DEPARTMENT OF TRANSPORTATION

Contract #: 04-0120F4Cty: SF/ALA Rte: 80 PM: 13.2/13.9File #: 69.25B**QUALITY ASSURANCE -- NON-CONFORMANCE REPORT****Location:** Changxing Island, Shanghai, P.R. China**Report No:** NCR-000717**Prime Contractor:** American Bridge/Fluor Enterprises, a JV**Date:** 25-Apr-2010**Submitting Contractor:** Zhenhua Port Machinery Company, Ltd (ZPMC), Changxing Island**NCR #:** ZPMC-0684**Type of problem:**

Reference Description: QC Missed 2 MT Transverse Indications on Segment 9EE U-Rib Deck Diaphragm welds

QUALITY ASSURANCE -- NON-CONFORMANCE REPORT

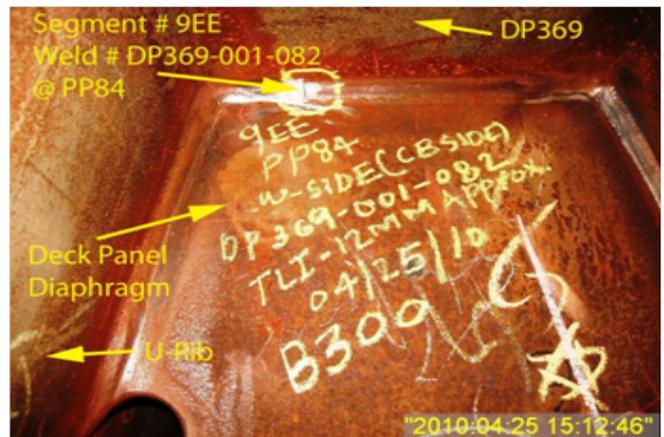
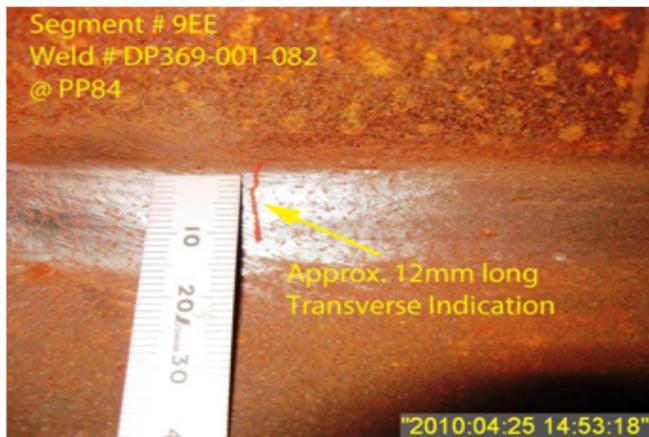
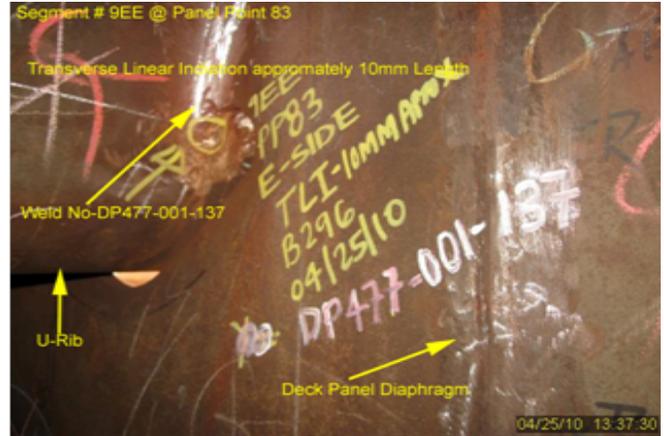
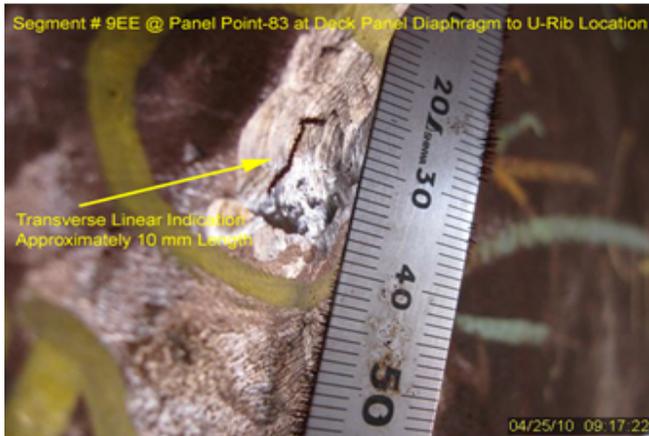
During the Quality Assurance (QA) Magnetic Particle Testing (MT) review of welds located on Segment 9EE, this QA Inspector discovered the following issues:

- One (1) Transverse linear crack like indication measuring approximately 12 mm in length.
- The weld is identified as DP369-001-082 @ Panel Point-084.
- The weld is a Fillet Weld T-joint joining the Deck Plate (DP369) to Deck panel diaphragm plate.
- OBG 9EE segment is located at the front side of OBG Blast Shop-1.

- One (1) Transverse linear indication measuring approximately 10 mm in length.
- Weld is a Complete Joint Penetration (CJP) Weld joining the Deck panel Diaphragm to U-Rib.
- Weld Identification number is DP477-001-137 @ Panel Point-083.
- Deck panel Diaphragm is identified as X1E.
- U-Rib is Identified as R18D.
- Location Panel Point (PP83).
- The OBG 9EE Segment is located at the back side of Painting Shop.

- The Notice of Witness Inspection Number (NWIT) is 005583.
- The indication is located inside the area that has been previously tested and accepted by ZPMC Quality Control (QC) personnel.

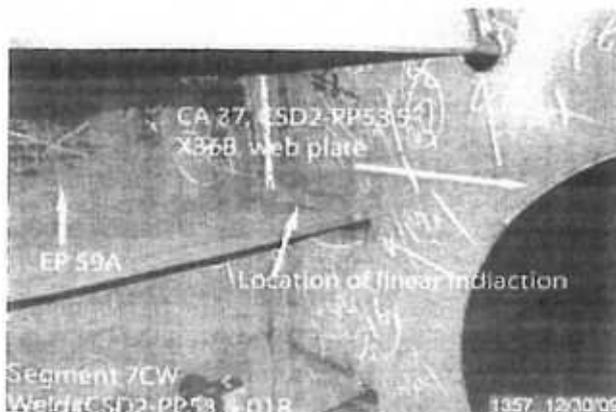
During the Quality Assurance Magnetic Particle Testing (MT) review of welds located on Segment 7CW, this Quality Assurance Inspector (QA) discovered the following issues:

- Two (2) Longitudinal linear indication measuring approximately 20mm and 25mm in length.
- The welds are identified as: CSD3-PP55-025, 026 (30 mm) and CSD2-PP53.5-018 (25 mm).
- The welds are a Fillet Weld type joining the Edge Plate (EP59A) stiffeners to Corner Assembly (CA37A) web plates.
- The OBG 7CW segment is located at in front of Blast Shop.

The Notice of Witness Inspection Number (NWIT) is 004947. The indication is located inside the area that has been previously tested and accepted by ZPMC Quality Control (QC) personnel. ZPMC's QC personnel are required to perform twenty five (25%) percent MT inspection of this weld.

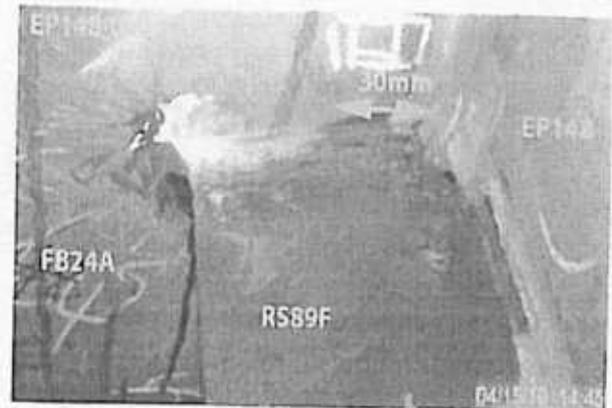
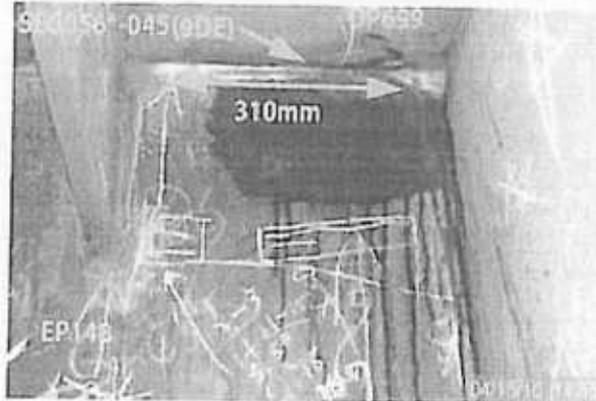
During the Quality Assurance (QA) Ultrasonic Testing (UT) review of welds located on Orthotropic Box Girder (OBG) Segment 9DE, this QA Inspector discovered the following issues:

-Two (2) longitudinal linear indications measuring approximately 310mm and 30mm in length.

-The indications dBs rating are +6 and +4.

-Material thickness is 18mm.

-The depth of the indications is approximately 11mm and 13mm.

-The welds are identified as SEG056*-045 at Panel Point (PP) PP81.5 and EP148-022 at PP 81.

-The Y distance for the indications are 50 mm from PP81.5 and 0 mm from EP148A.

-Weld SEG056*-045 is a Complete Joint Penetration (CJP) Corner joint, joining the Edge Plate PL1336C (SPCM) to Deck Plate PL1314A (Non SPCM).

-Weld EP148-022 is a Complete Joint Penetration (CJP) "T" joint, joining the Edge Plate stiffener RS89F (Non SPCM) to FB24A plate PLX24D (SPCM).

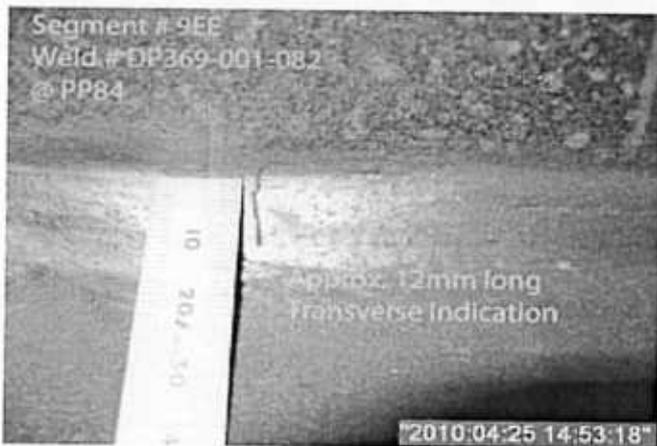
-One (1) Transverse linear indication measuring approximately 10 mm in length.

-Weld is a Complete Joint Penetration (CJP) Weld joining the Deck panel Diaphragm to U-Rib.

-Weld Identification number is DP477-001-137 @ Panel Point-083.

-Deck panel Diaphragm is identified as X1E.

-U-Rib is Identified as R18D.

-Location Panel Point (PP83).

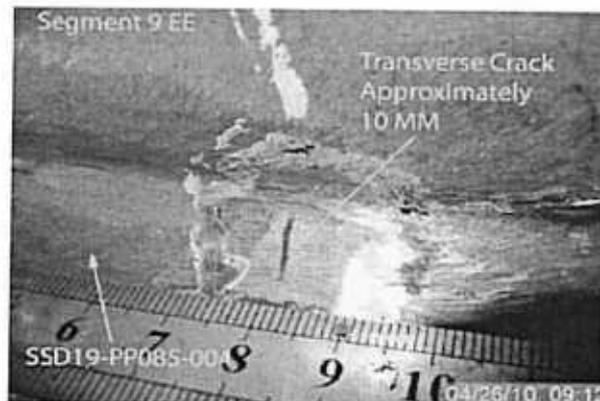
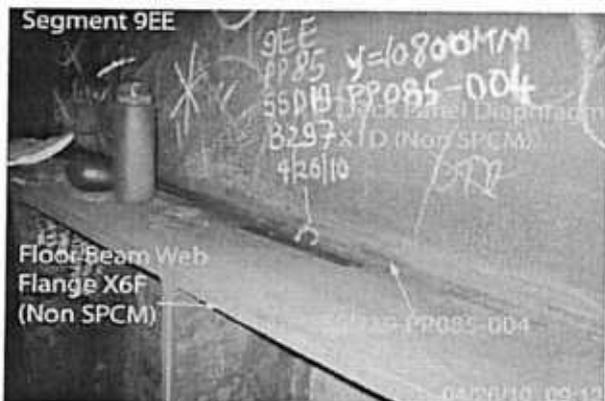
During the Quality Assurance (QA) Magnetic Particle Testing (MT) review of welds located on Segment 9EE, this QA Inspector discovered the following issues:

- One (1) transverse crack measuring approximately 10mm in length in the fillet weld joining the Deck Panel Diaphragm (X1D) to Floor Beam Web Flange (X6F) at panel point 85.
- The Y location is 10800mm from the termination of the weld on the crossbeam side.
- The indication is clearly marked near the weld.
- The weld is identified as: SSD19-PP085-004.
- OBG segment 9EE is located north of the blast shop.
- The Notice of Witness Inspection Number (NWIT) is 005583. The indication is located within the area that has been previously tested and accepted by ZPMC Quality Control (QC) personnel.

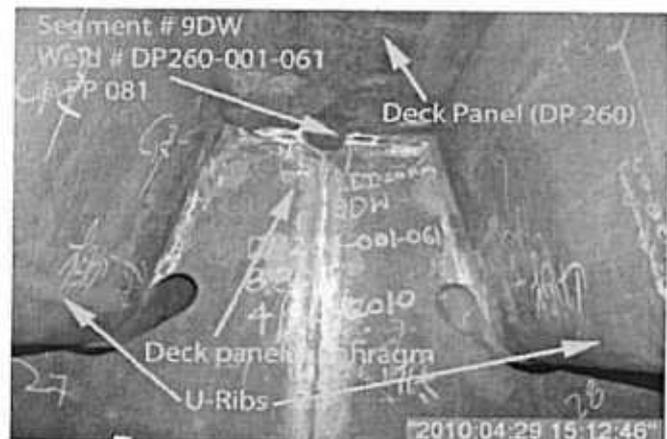
Reference Description: Missed MT indication by QC on Segment 9DW Deck Panel to Diaphragm

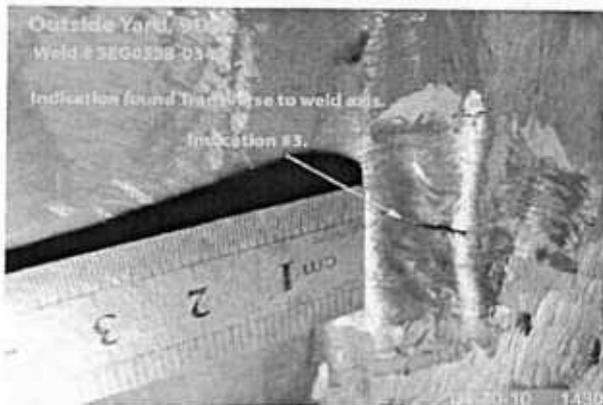
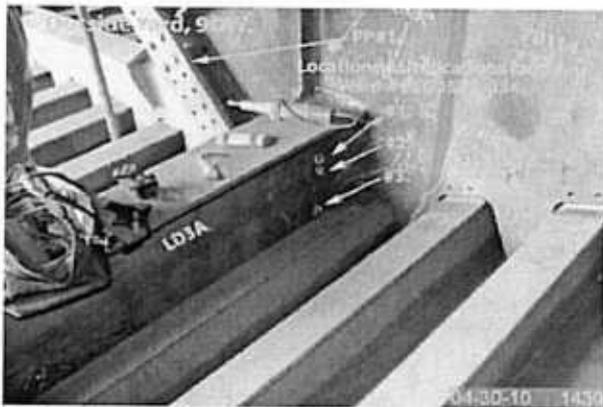
On April 30, 2010:

- Three transverse linear indications, one measuring approximately 9mm and two indications measuring approximately 5mm in length at Longitudinal Diaphragm (LD) LD3A to Floor beam (FB) FB11A.
- Weld is identified as SEG055B-034 and designated as a Fracture Critical Weld (FCW).
- The weld is a 14mm Complete Joint Penetration (CJP) T-joint joining LD 3A shear plate identified as X39B to FB web plate identified as X47C (Seismic Performance Critical Material SPCM).
- The indications are clearly marked on the material.

On May 1, 2010:

- One (1) Longitudinal linear indication measuring approximately 18mm in length.
- The Y location is 7mm from the cope hole.
- The indication is clearly marked on the material near the weld.
- The weld is identified as: CSD9-PP81-062.
- The weld is designated as Seismic Performance Critical Member (SPCM).
- The weld is located at PP81 (Counter Weight Side).
- The weld is a Fillet Weld T-joint joining the Corner Assembly Diaphragm identified as X11B (SPCM) to Side Plate identified as SP658 (SPCM).
- OBG segment 9DW is located west of Bay #14.
